**PLANNED UNIT DEVELOPMENT
& SUBDIVISION STAFF REPORT****August 18, 2016**

<u>DEVELOPMENT NAME</u>	Mullinax Ford Subdivision
<u>SUBDIVISION NAME</u>	Mullinax Ford Subdivision
<u>LOCATION</u>	Southeast corner of Airport Boulevard and Portside Boulevard extending to the Southwest corner of Airport Boulevard and Lakeview Drive
<u>CITY COUNCIL DISTRICT</u>	District 6
<u>AREA OF PROPERTY</u>	1 Lot / 11.0 ± acres
<u>CONTEMPLATED USE</u>	Planned Unit Development Approval to allow multiple buildings on a single building site with shared access and parking, and to create one legal lot or record from five existing legal lots and two parcels.
<u>TIME SCHEDULE FOR DEVELOPMENT</u>	None given.
<u>ENGINEERING COMMENTS</u>

The applicant is requesting Planned Unit Development Approval to allow multiple buildings on a single building site with shared access and parking, and to create 1 legal lot of record from 5 existing legal lots of record and 2 parcels. The site is located in Council District 6, and according to the applicant is served by public water and sanitary sewer.

SITE PLAN

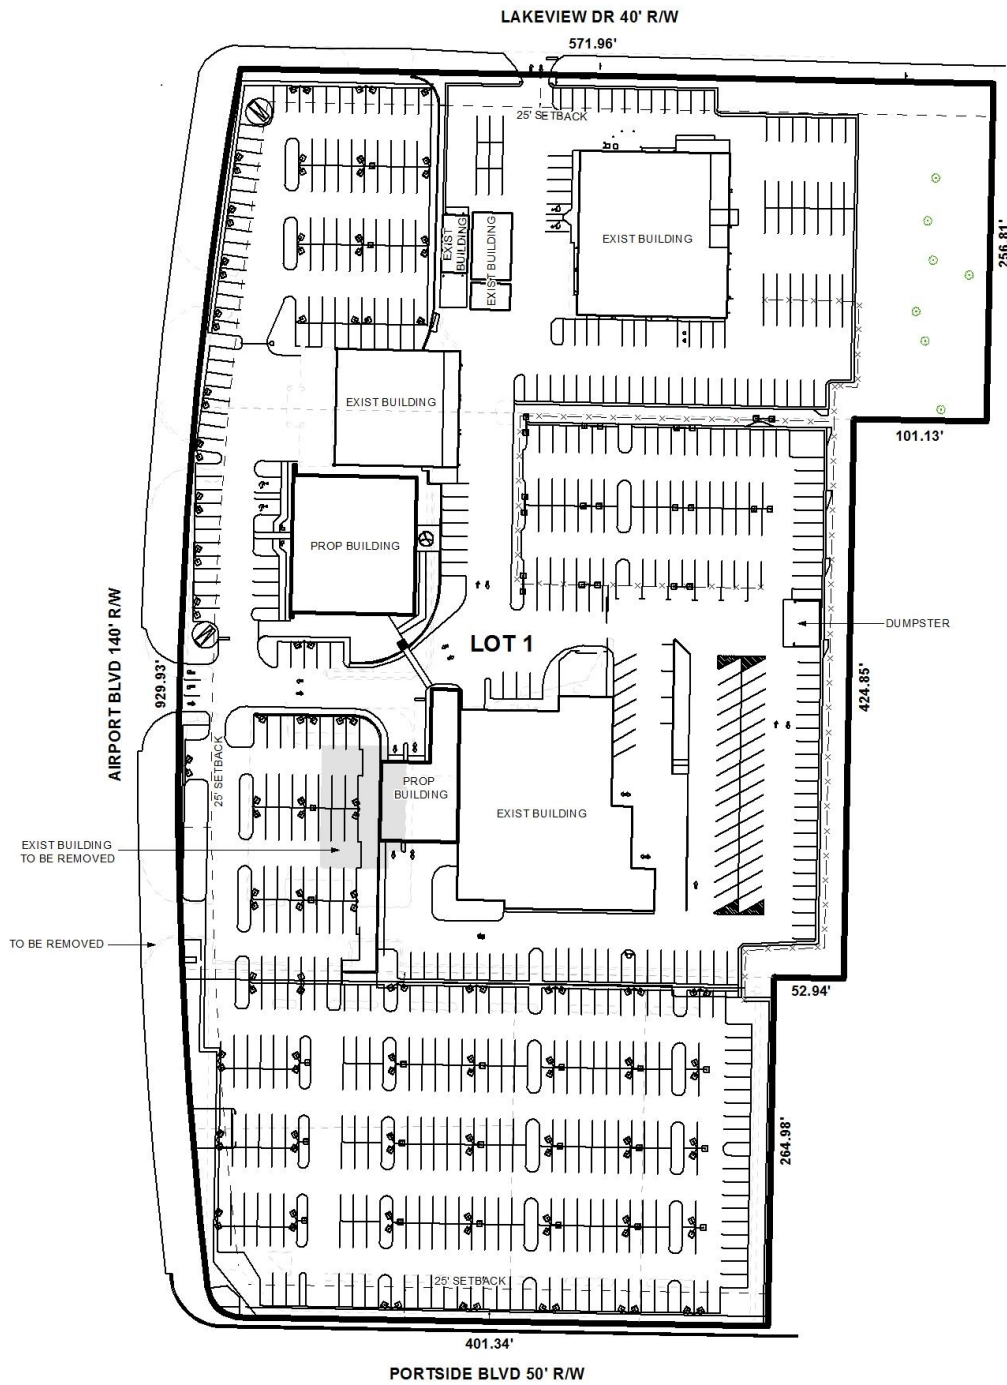
Staff cannot determine if the site meets the minimum tree and landscaping requirements, however, the amount of demolition and new construction will not trigger full compliance. Nonetheless, site plan should be revised to depict the existing total landscaping and total frontage landscaping calculations as well as the proposed total landscaping and total frontage landscaping calculations.

The site plan depicts a table illustrating a parking summary, but square footage of the existing and proposed buildings is not depicted. However, of the 695 parking spaces, 80 spaces are designated for employee parking and 48 spaces are designated for sales for the customers.

A note is depicted on the site plan that illustrates a newly proposed "Lincoln" pylon sign. The site currently has three non-conforming free standing signs and several wall signs which were present when the site was annexed into the city limits. Staff is unaware of the total square footage of both the existing and proposed signs and sufficient justification explaining the need for the additional pylon sign was not expressed. Typically the number of signs that are currently on the site would not be allowed unless otherwise approved by a variance from the Board of Zoning Adjustment. Due to the complexity of the site and amount of existing signage, staff believes the request for the "Lincoln" pylon sign should be presented to the Board of Zoning Adjustment.

A sidewalk is not depicted on the site plan. Due to the proposed work in the right-of-way, with the closing of existing curb-cuts, the applicant should provide a sidewalk along all street frontages of the property or apply for a sidewalk waiver.

- 1) revision of lot size in square feet and acres to reflect dedication on the site plan;
- 2) revision of the site plan to reflect dedication to provide 25' from centerline along Lakeview Drive;

- 3) revision of the site plan to depict the 25' minimum building setback line to reflect dedication as needed;
- 4) revision of the site plan to reflect a corner radius in compliance with Section V.D.6. of the Subdivision Regulations at the intersection of Lakeview Drive and Airport Boulevard;

- 5) placement of a note on the site plan stating no structures shall be placed in any easements;
- 6) retention of the right-of-way widths on the site plan;

- 7) placement of a note on the site plan stating the site should be limited to the proposed 1 curb-cut to Airport Boulevard and the proposed 1 curb-cut to Lakeview Drive with size, location and design to be approved by Traffic Engineering and conform to AASHTO standards;

- 8) revision of the site plan to depict a sidewalk along all street frontages or the submission of a sidewalk waiver;
- 9) revision of the site plan to depict the existing total landscaping and total frontage landscaping calculations as well as the proposed total landscaping and total frontage landscaping calculations;

- 10) retention of all existing notes on the site plan;
- 11) a photometric plan in compliance with Sections 64-4.A.2., 64-6.A.3.c., and 64-6.A.8. of the Zoning Ordinance will be required at the time of submittal for building permits;

- 12) submission of a sign variance application to the Board of Zoning Adjustment to allow for the “Lincoln” pylon sign;
- 13) compliance with Traffic Engineering comments: *“Site should be limited to no more than two curb cuts to Airport Boulevard, and one curb cut to Lakeview Drive, with size, location and design to be approved by Traffic Engineering and conform to AASHTO standards. Any unused curb cuts should be removed from the right-of-way in conjunction with land disturbance permits for new building construction. Any new on-site parking, including ADA handicap spaces, shall meet the minimum standards as defined in Section 64-6 of the City’s Zoning Ordinance.”*
